Cottesloe Foreshore Renewal Summary Strategy - Resident Feedback
Summary of Submissions Received - Closing date, 23 October 2017

Cottesloe Foreshore Renewal Summary Strategy - Community Feedback
Summary of Submissions Received - Closing date, 23 October 2017

Cottesloe Foreshore Renewal Summary Strategy

PERSPECTIVE 3. VIEW EAST TOWARDS COTTESLOE SLSC

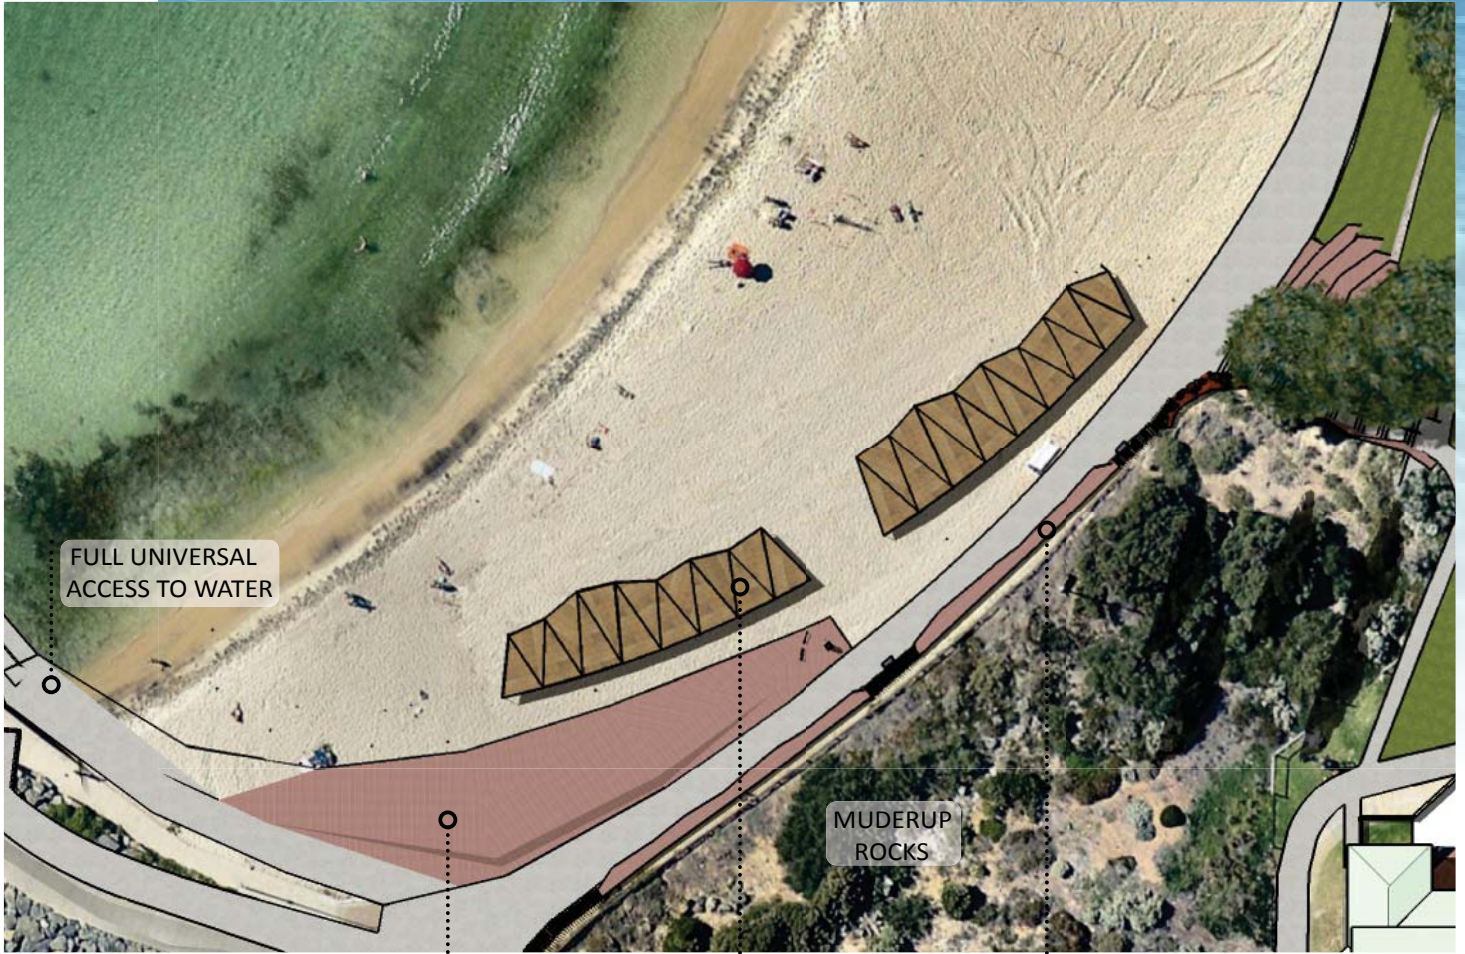
62	Philip Angers	Supports the revitalising of the Cottesloe Foreshore Precinct with improved amenities, pedestrian accessibility and the effective planning of public open spaces. If the aggregate concrete is sealed it might be slippery. Prefer more natural looking limestone blocks. Shade/shelter perspective four - could this include more seating rather than a viewing ramp. Concerned about the shade materials being removed in summer, the poles will be left looking unsightly. Unsure of tunnel slides and the umbrella shade due to the sea breeze. Supports the idea of pop-up markets, postcode parties, seafood festival and wellness bookings. Will require more lighting in the area. Suggests inviting shops from the Cottesloe village. The trial could extend to May because the weather is still great.
63	Shirley Primeau	The proposed strategy needs to be revised. Concerned the beachfront will look like a theme park and too plastic fantastic. Agrees that broken items should be replaced, but the need to replace items because they look outdated is not reasonable. The use of signage is too much both in quantity and cost. Provided signage example from Fremantle. A better use of funds would include a pedestrian friendly/biking boulevard - Claremont has successfully done this in their shopping precinct. More trees and under storey plantings. Does not support pop-up seating and umbrellas because they will break quickly and will need replacing. The toilets on the foreshore need to be upgraded as a priority. Attached example of self-cleaning toilet. The design concentrates too much on building structures rather than enhancing the natural environment. No more development on the west side of Marine Parade.
